MODEL
2014~2016MY
Cadenza (VG)
2014~2015MY
Sorento (XMa) w/
3.3L GDI

NUMBER
148 (Rev 4, 9/20/2016)

TECHNICAL SERVICE BULLETIN

SUBJECT: CHATTER/RATTLE NOISE FROM ENGINE AFTER COLD SOAK

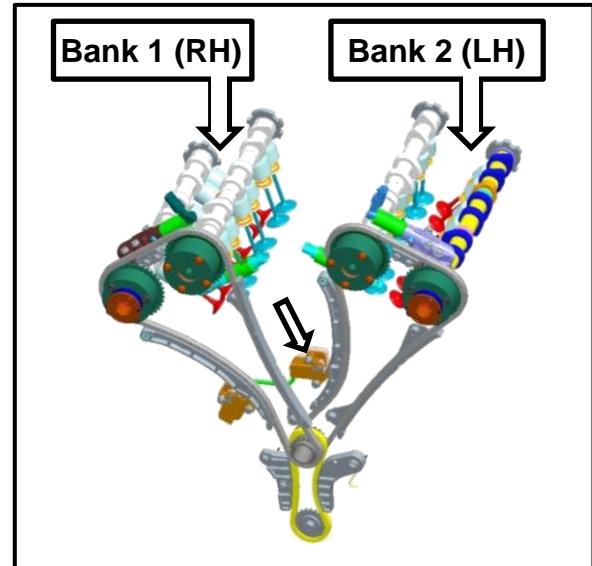
This Service procedure should **ONLY** be performed on engine bank 2 (LH), as shown.

1. Refer to the “Engine Mechanical System → Timing System → Timing Chain” section in the applicable Workshop Manual on KGIS, to install the improved timing chain tensioner.
2. For XMa vehicles, confirm that the latest intake CVVT is installed by referencing the part number shown on page 3 of this bulletin.

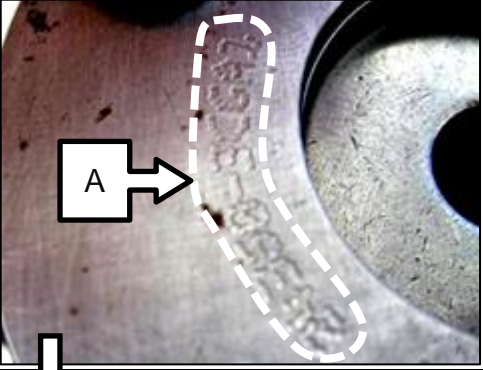
New tensioner design with finer pitch on teeth (1.5mm)
